# **MEMORANDUM**

**Subject:** Coccimiglio Accessory Structure (Conditional Use Permit

8878 S. Taft Hill Ct.

CUP-03-21-6013 Zoned R-1-8

Exhibit #3 – Easement

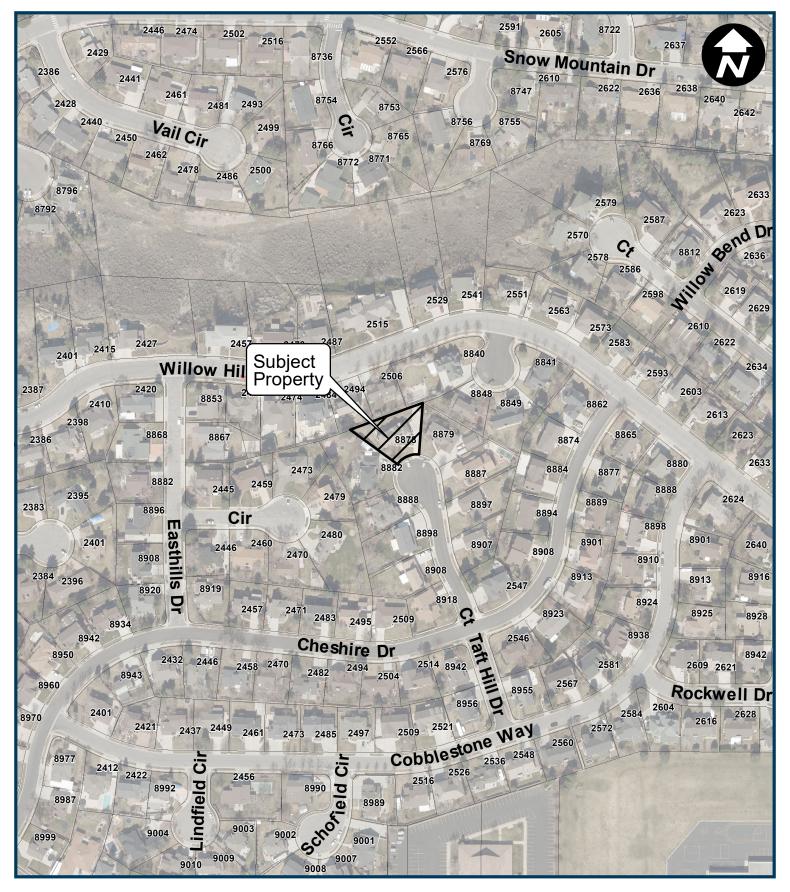
Staff is concerned about the easement that crosses the northeast side of the property (Exhibit #3 – Easement). The proposed structure would encroach into this 14-foot easement. The amount of encroachment permitted will be determined by the utility companies. The applicant is aware of this concern and is working to obtain easement letters.

- 1. Setbacks along the side and rear yard should be a minimum of four feet from the side and rear property lines unless this requirement is waived by the Planning Commission.
- 2. That the 160 square foot existing shed be demolished.
- 3. That the materials utilized be those described in the staff report.
- 4. That the proposed structure complies with all applicable Building & Safety, and Fire & Life Codes.
- 5. That the applicant obtains easement letters and abides by any special requirements from the utility companies.
- 6. That the applicant be responsible for meeting all provisions of the Sandy City Development Code, and all conditions of approval imposed by the Planning Commission.
- 7. That this Conditional Use Permit be reviewed upon legitimate complaint.
